NRC DOCKET 50-366  
OPERATING LICENSE NPF-5  
EDWIN I. HATCH NUCLEAR PLANT UNIT 2  
PROPOSED TECHNICAL SPECIFICATIONS

The proposed amendment to the Unit 2 Technical Specifications, Appendix A to the Operating License, would be incorporated as follows:

MAXIMUM AVERAGE PLANAR LINEAR HEAT  
GENERATION RATE (MAPLHGR)  
VERSUS AVERAGE PLANAR EXPOSURE  
FIGURE 3.2.1-2

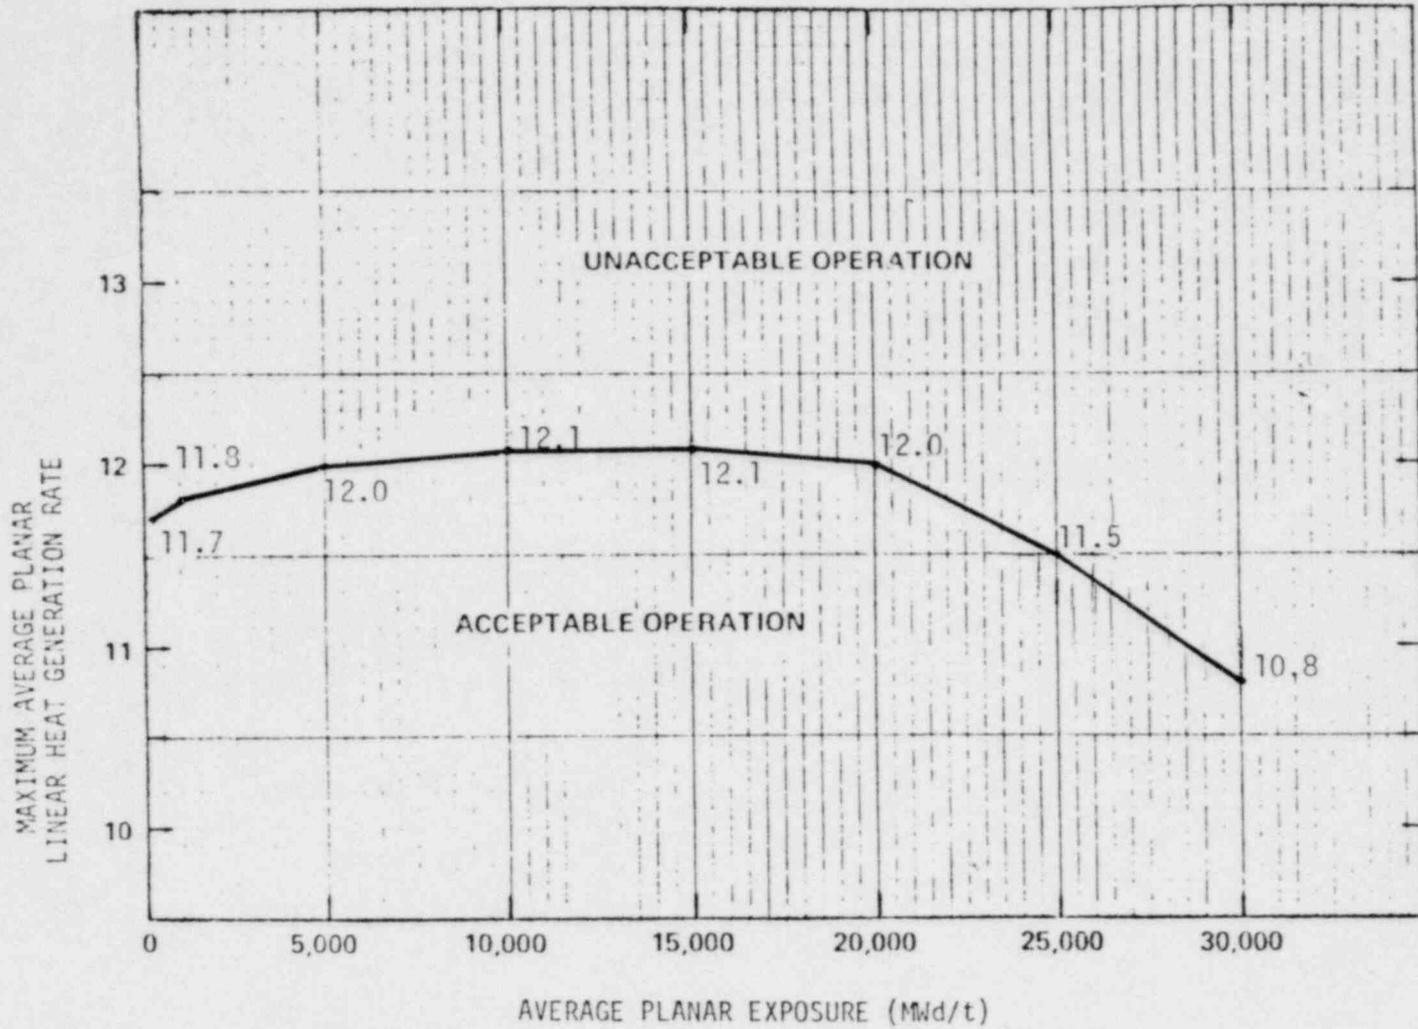
3.2.1 All AVERAGE PLANAR LINEAR HEAT GENERATION RATES (APLHGRs) for each type of fuel as a function of AVERAGE PLANAR EXPOSURE shall not exceed the limits shown in Figures 3.2.1-1, 3.2.1-2, 3.2.1-3, or 3.2.1-4.

4.2.1 All APLHGRs shall be verified to be equal to or less than the applicable limit determined from Figure 3.2.1-1, 3.2.1-2, 3.2.1-3, or 3.2.1-4:
